## Development Permit Panel

Wednesday, June 27, 2018  
3:30 p.m.

1. **DEVELOPMENT PERMIT 16-728670**  
(REDMS No. 5828465, 5877234)

PROPERTY LOCATION: 6571 No. 4 Road (formerly 6571/6573 No. 4 Road)

PLAN #3B JUN 20 2018

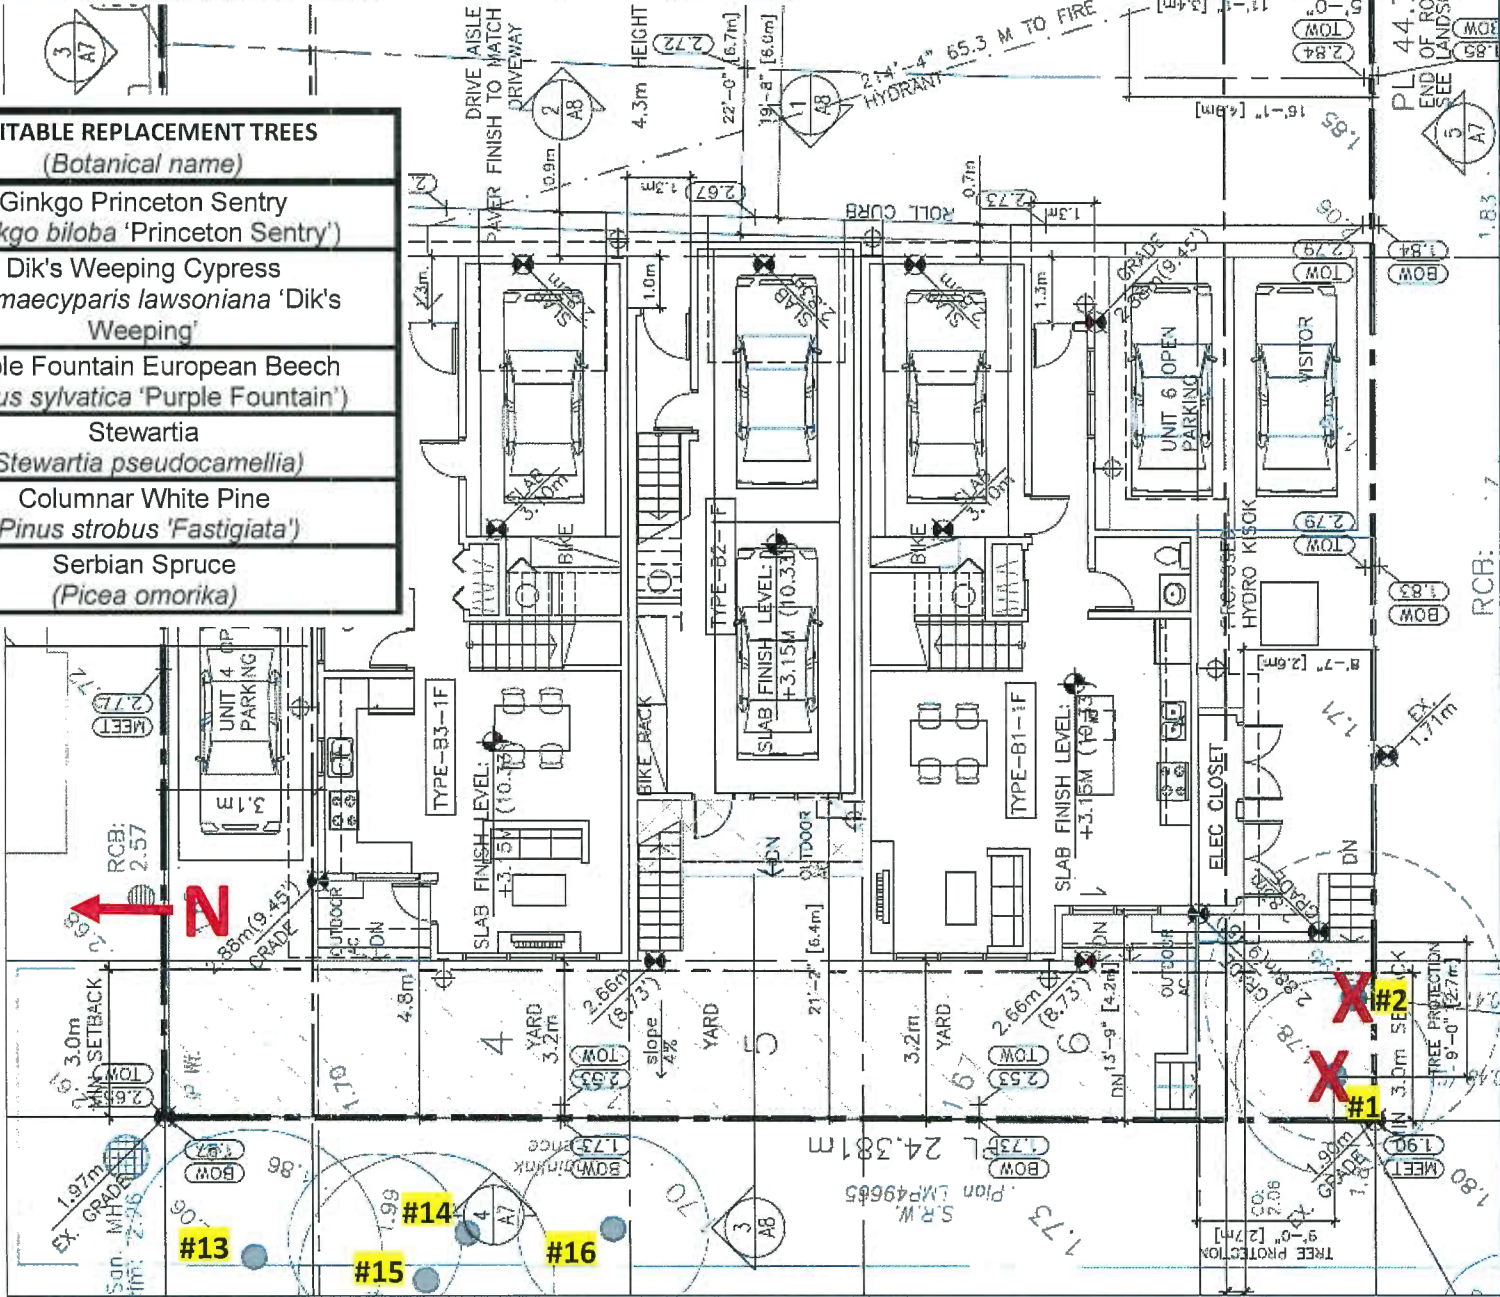
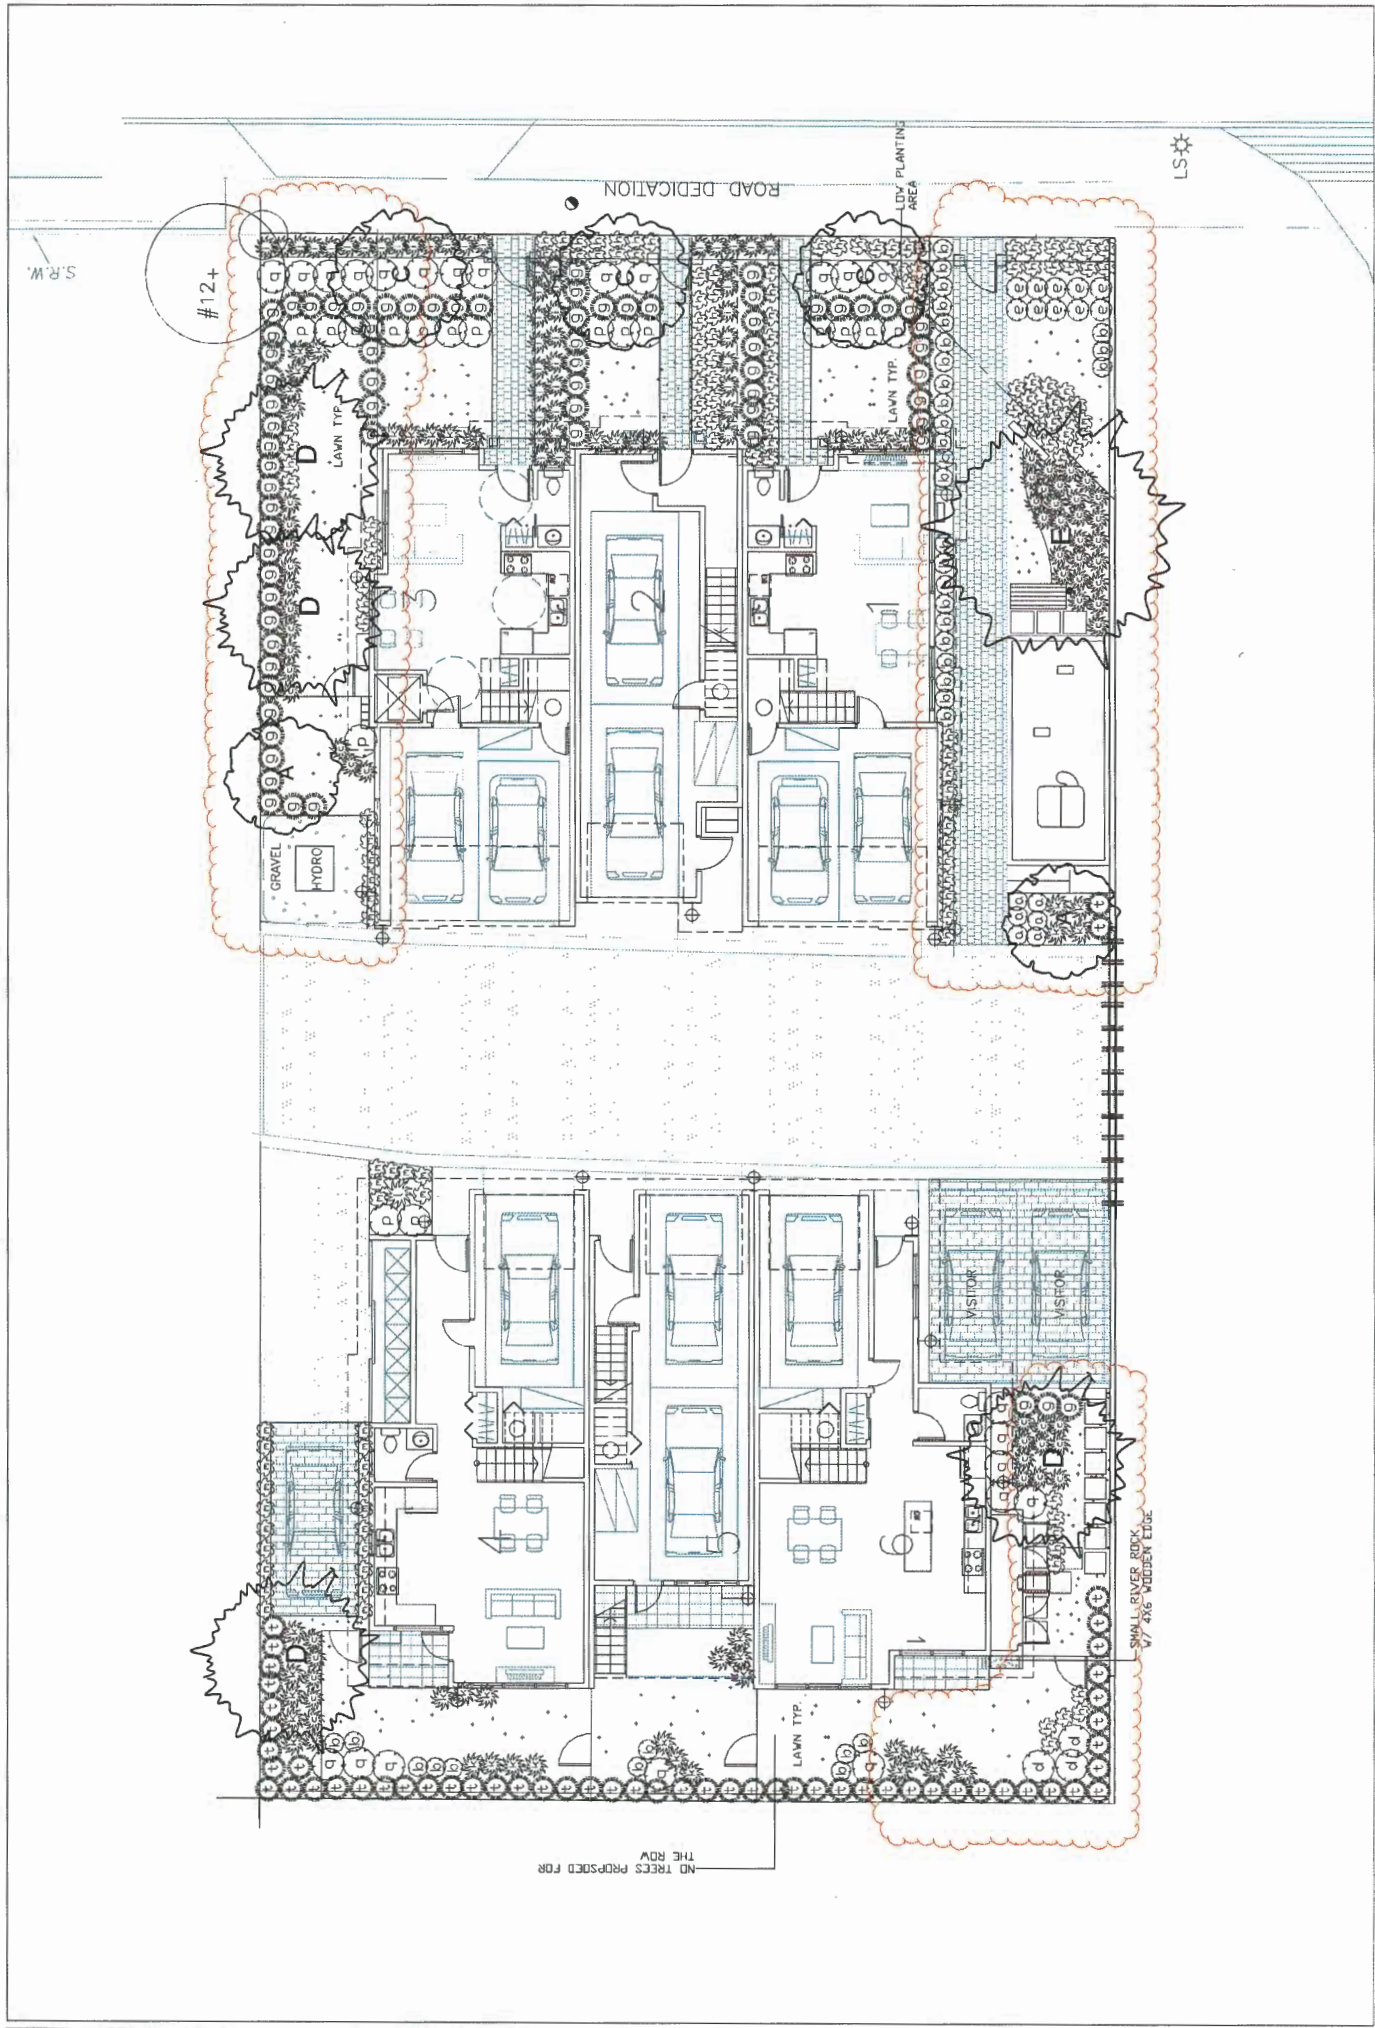
- The applicant is proposing to swap the locations of the proposed onsite pedestrian walkway and the outdoor amenity space at the southeast corner of the site, bringing the outdoor amenity space slightly to the south to a location along the south property line. The proposed pedestrian walkway connecting No. 4 Road to the internal drive aisle of the site is being shifted slightly to the north (see Plan #3A).

The site plan and landscape plan have been revised to allow the 40 cm Western Red Cedar replacement to relocate to the south side of the subject site, which would allow a much larger open space for the replacement tree.

The applicant is proposing to replace the dying 42 cm calliper Western Red Cedar tree located at the southwest corner of the site with a new 40 cm calliper Western Red Cedar tree at the northeast corner of the site. This proposal has been reviewed and accepted by the City's Tree Preservation Coordinator. As fines have been issued to the owner and the pre-load contractor already, no additional compensation is requested.
